**RTCA Special Committee 209 / EUROCAE WG49**

**ATCRBS / Mode S Transponder MOPS Maintenance**

**Joint Meeting #11**

**Loss of Mode A Code change alert after a switch-off/on**

### 2.2.18.2.7 Flight Status and Vertical Status Protocols (Figure 2-17)

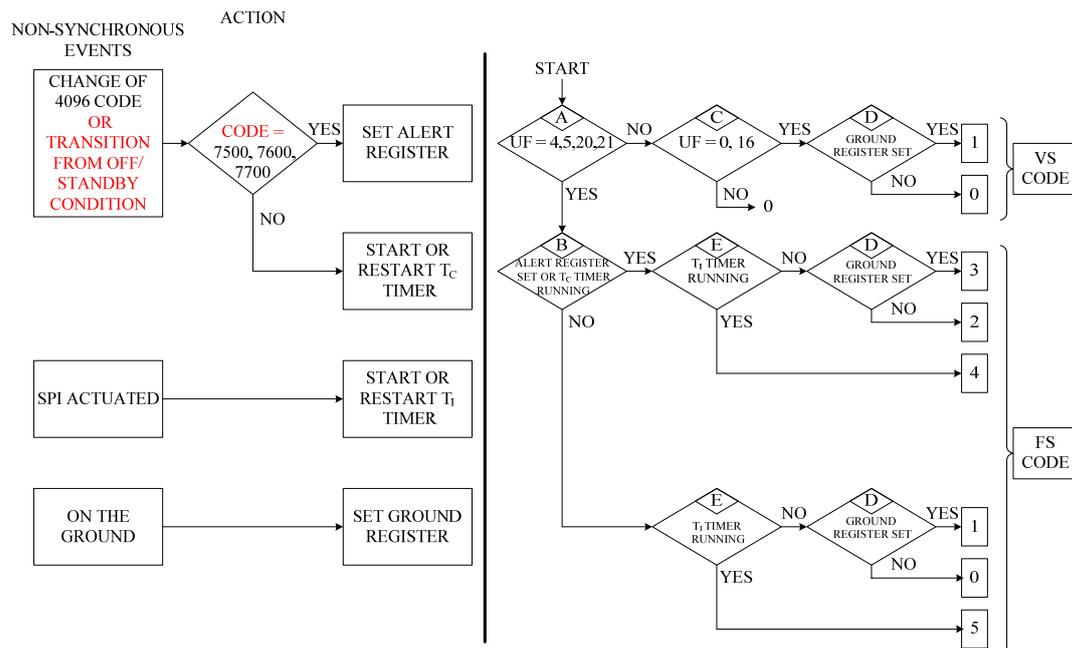
This WP proposes to come back on this issue and to eliminate the loss a Mode A code change by requiring the transponder to set an alert once it is leaving the Off or standby condition. Similarly this WP is also proposing to force the broadcast of the data-link capability register when leaving the standby condition. The case of the aircraft Identification needs to be discussed as it is a data not changing very often.

In this case Fig 2-17 should be modified as follows:

- a. Alert – The transponder **shall** transmit the 4096 identification code in ATRBS Mode A replies and in the ID field of downlink format DF=5. This code can be changed by the pilot, and when a change is made an alert condition **shall** be established. If the identification code is changed to 7500, 7600 or 7700, the alert condition **shall** be permanent. If the identification code is changed to any other value, the alert condition **shall** be temporary and self-cancelling after 18 ±1 seconds (TC timer). The TC timer **shall** be retriggered and continued for 18 ±1 seconds after any change has been accepted by the transponder function. Transponder memorizing the last mode a code entered. **When transitioning from Off or standby condition to any operational mode, the transponder shall set the temporary alert condition.** The alert condition **shall** be reported in the FS field. The permanent alert condition **shall** be terminated and replaced by a temporary alert condition when the identification code is set to a value other than 7500, 7600 or 7700.
